Subject: UniStar Nuclear Energy, NRC Docket No. 52-016  
Response to Request for Additional Information for the  
Calvert Cliffs Nuclear Power Plant, Unit 3,  
RAI No. 304, Seismic System Analysis

**Response to NRC Request for Additional Information  
RAI No. 304, Questions 03.07.02-55, 03.07.02-58, and 03.07.02-59,  
Seismic System Analysis,  
Calvert Cliffs Nuclear Power Plant, Unit 3**

**RAI No. 304**

Figure 1: Cracked Elements for SSE Analysis – Basemat

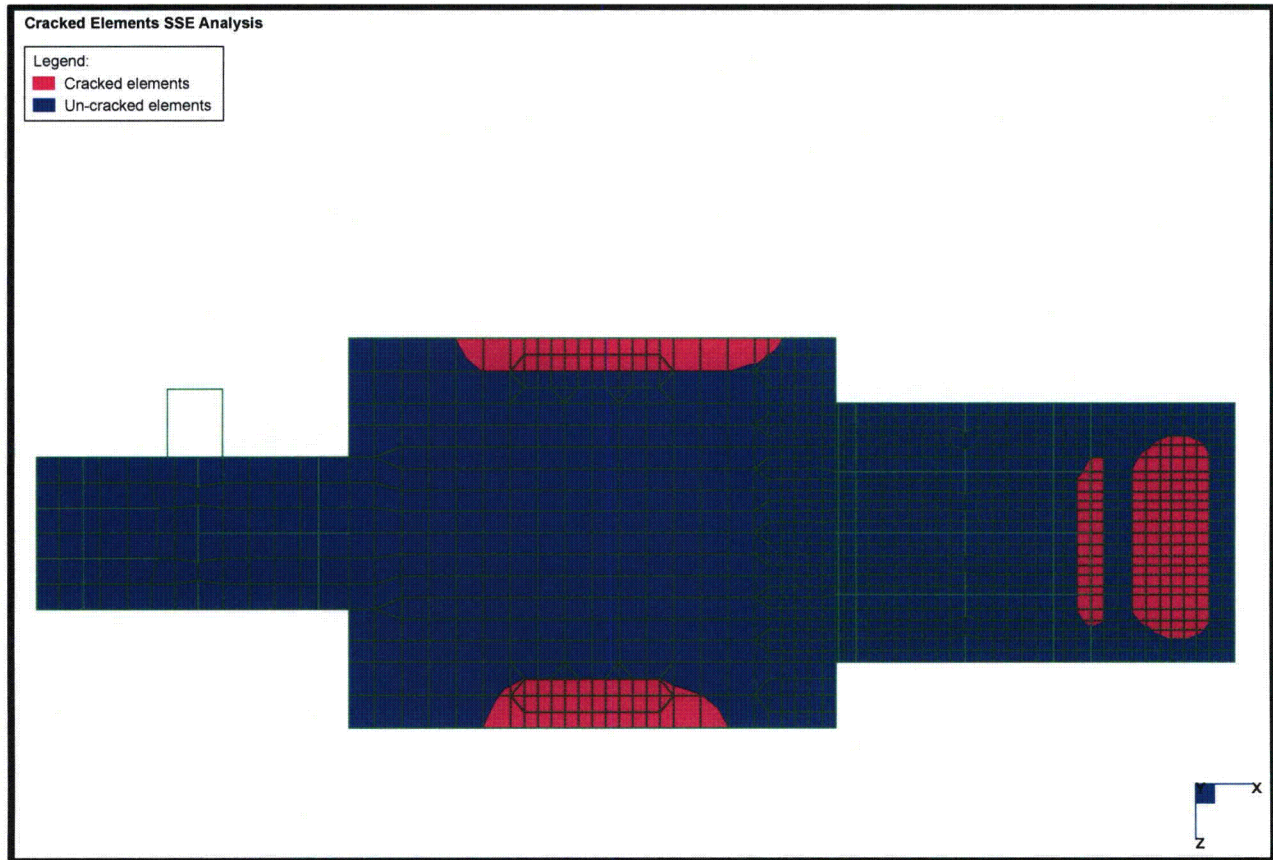
1. The response states that in Figures 1-4 cracked elements are magenta and un-cracked elements are blue. The key in the upper left hand corner of each figure is not clear, and could be interpreted to imply just the opposite. The applicant is requested to clarify which elements are cracked and which are un-cracked by providing a key which clearly identifies which is which.
2. Provide the criteria that were used to determine that a section was cracked, and the loads and loading combinations that were used for this determination.

Figures 1 through 4 have been revised (see attached) with a color key that clearly identifies the location of the cracked elements.
